UNITED STATES PATENT AND TRADEMARK OFFICE

Office Action Summary	Application No. 10/590,982	Applicant(s) MIMURA, IKUO	
	Examiner GERARD T. HIGGINS	Art Unit 1794

DETAILED ACTION

Fig. 1

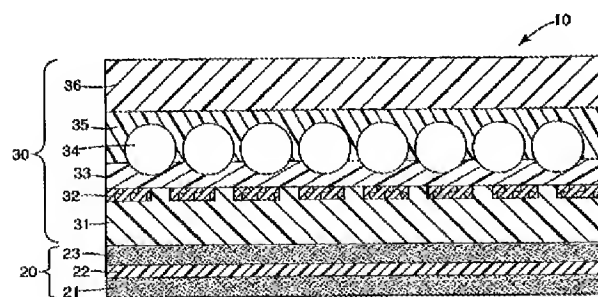
With regard to claim 1, Hingsen-Gehrmann et al. disclose the tamper-indicating articles, which read on applicants' display device, of Figures 1, 2, and 5.

The device is comprised of a top film **70**, which reads on applicants' surface-protective layer, a print layer **60**, which reads on applicants' information display layer, a retroreflective sheet **30**, which reads on applicants' light-reflective resin sheet, and an adhesive layer **20**, which reads on applicants' substrate adhesive layer [0034]-[0052], [0069] and [0079]. There is a reflective layer **31**, which reads on applicants' specular reflective layer, that is a part of the retroreflective sheet **30** that also has a release layer **32**, which reads on applicants' destructive layer installed on one side thereof, and the device is installed on an substrate **90**, which reads on applicants' installation substrate, via the adhesive layer; further, when the device is tampered with it results in the structure seen in Figure 2 [0072]. Hingsen-Gehrmann et al. teach that their release layer is preferably made of polyesters [0059]. There is a destructive effect wherein separation takes place between the release layer and one of the other layers constituting the retroreflective sheet; however, Hingsen-Gehrmann et al. fail to disclose an auxiliary substrate between the display device and the installation substrate, and they also fail to disclose the polymer resins of the destructive layer as claimed.

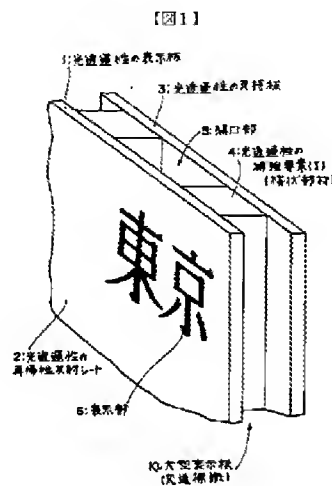
Shimizu discloses further reinforcement-elements **4**, which reads on applicants' auxiliary substrate, between the plotting board **1**, which reads on applicants' display device, and a support plate **3**, which reads on applicants' installation substrate. Please see Figure 1, Abstract, and [0021].

The auxiliary substrate can be mechanically fixed on the installation substrate [0021]; further, one of ordinary skill would understand this to be intrinsic in the reference, otherwise the sign would fall to the ground.

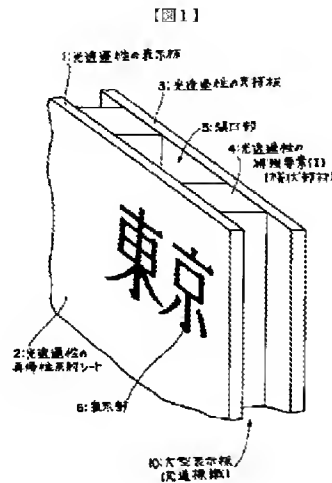
Shimizu discloses further reinforcement-elements **4**, which reads on applicants' auxiliary substrate, between the plotting board **1**, which reads on applicants' display

device, and a support plate **3**, which reads on applicants' installation substrate. Please see Figure 1, Abstract, and [0021].

The auxiliary substrate can be mechanically fixed on the installation substrate [0021]; further, one of ordinary skill would understand this to be intrinsic in the reference, otherwise the sign would fall to the ground.
